# Errata for the FT-1000MP Operating Manual

The following information outlines some corrections that are needed to be made in the operating instructions for the FT-1000MP manual. You can keep this as a reference, or else make the changes to the appropriate sections of the manual by marking in corrections, as needed. We apologize for this inconvenience, and appreciate your patience and understanding.

## **PACKET jack pinout**

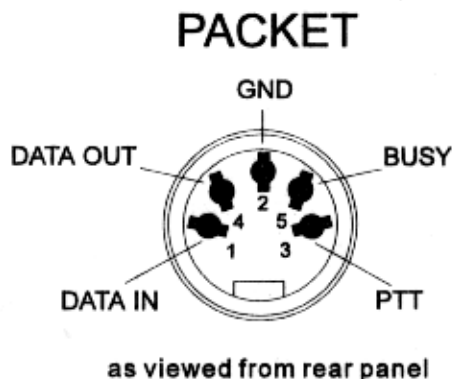
The pin connection information for the rear-panel **PACKET** jack is incorrect as it appears on pages 4 and 53. The correct pin-out sequence is shown below:
